Subject: Docket No. 50-206
Auxiliary Feedwater Pump G10W, 48-Hour Endurance Run
San Onofre Nuclear Generating Station
Unit 1

The following information provides a summary of the conditions and results of the 48-hour endurance test of the third Auxiliary Feedwater pump, G10W.

Figure 1
Guide to Obtaining G10W Bearing
Vibration Data

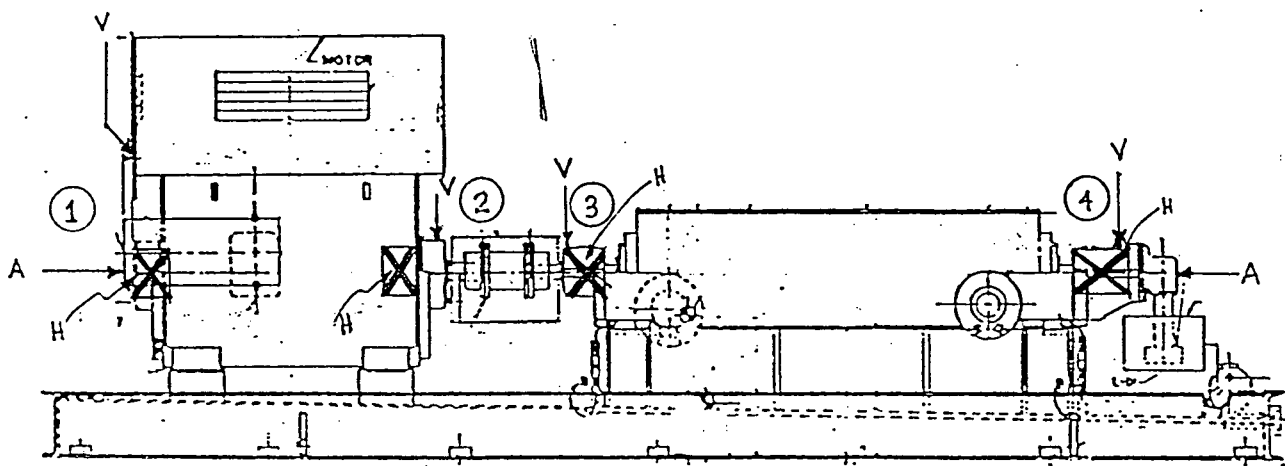
1. Provide a brief description of the test method (including flow schematic diagram) and how the test was instrumented (i.e., where and how bearing temperatures were measured).

Pump bearing lube oil temperatures were measured utilizing surface pyrometers which were inserted into thermal wells at the outboard bearing and lube oil cooler inlet and outlet piping. Pump inboard bearing temperatures were obtained using a surface pyrometer on the bearing caps. Motor bearing temperatures were obtained by reading the normally installed temperature elements using fluke multi-meters. Wahl Model 392 MX Platinum Pyrometers were used for the surface pyrometer. Vertical, horizontal and axial (where possible) vibration readings were measured with an IRD Model 308 vibration analyzer at the pump and motor inboard and outboard bearings as shown in Figure 1.

Figure 3
G10M Endurance Run Data - Plot of Motor Bearing Temperatures
(TE-5069 and TE-5070)

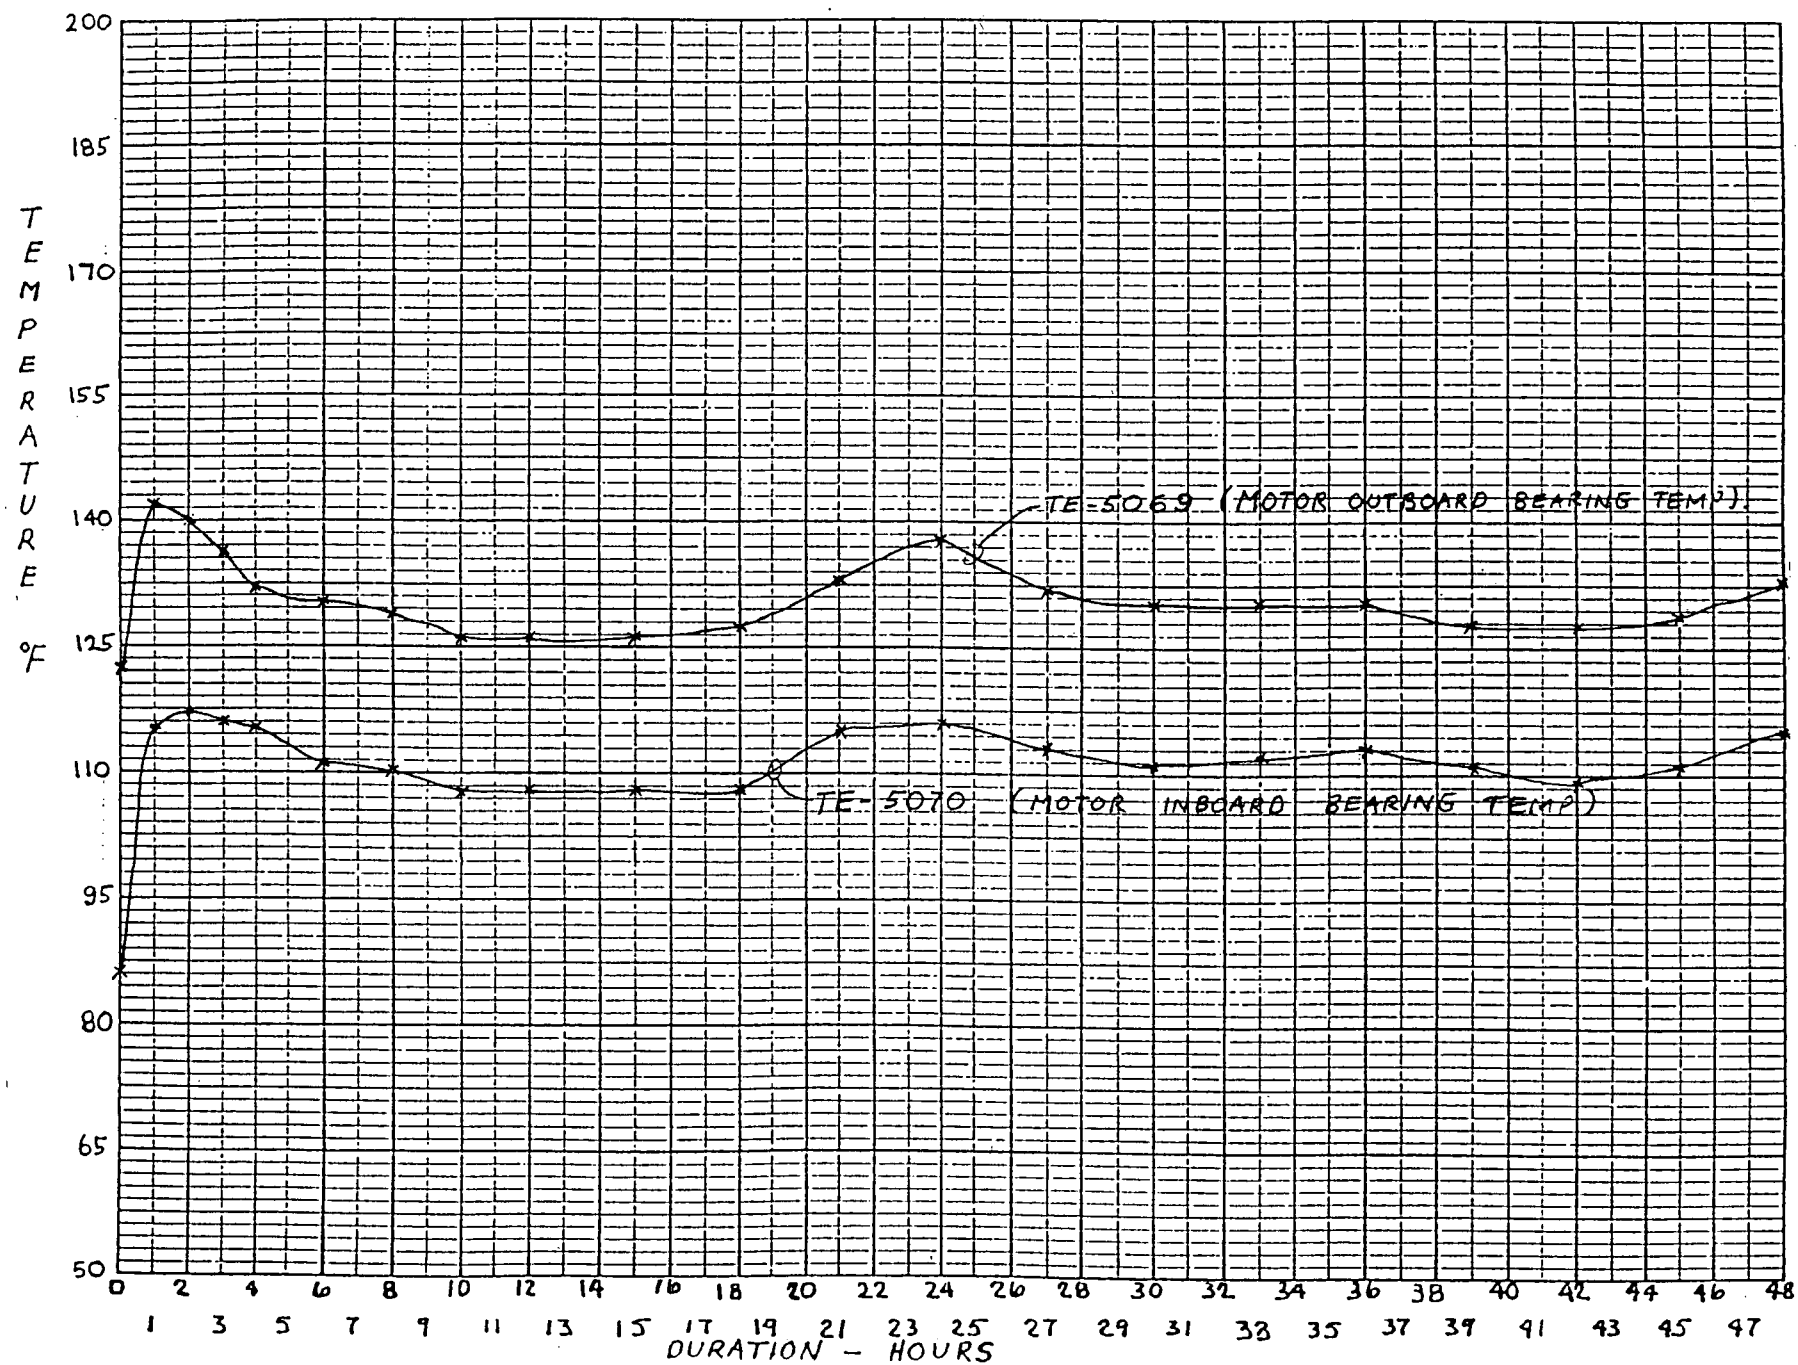
3. Provide plots of bearing/bearing oil temperature versus time for each bearing of the AFW pump/driver demonstrating that temperature design limits were not exceeded.

Pump and driver bearing temperatures were recorded throughout the endurance test. Plots of bearing and bearing lube oil temperatures (pump and driver) versus time for the AFW pump are shown on Figures 3, 4 and 5. A tabulation of these results was extracted from the endurance run test procedure and is provided as Enclosure 2. All bearing and lube oil temperature readings remained within the acceptance criteria during the endurance tests. The acceptance criteria were as follows:

1. Motor bearing temperature not exceeding 194°F,
2. Pump bearing lube oil temperature not exceeding 155°F, and
3. Lube oil temperature out of the lube oil cooler not exceeding 128°F.
